SI-160719

Service-Information Turbocharger

Information about connecting the actuator

Amended actuator:

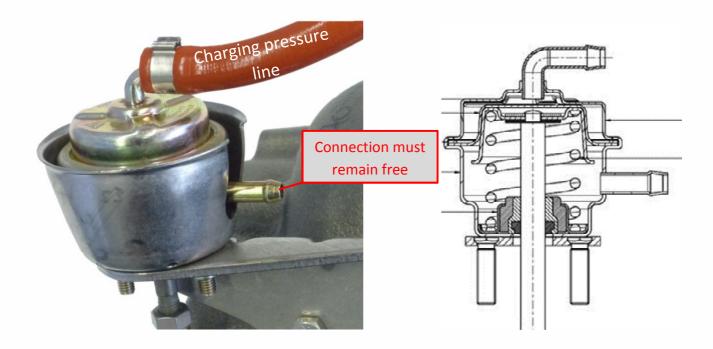
The manufacturer has made a technical change to the control box.

Correct connection to the actuator:

Boost pressure hose for activating the control box is already connected by the manufacturer.

The lower ventilation port is used exclusively for ventilation of the membrane opposite side and has to be kept open. Here no line must be connected.
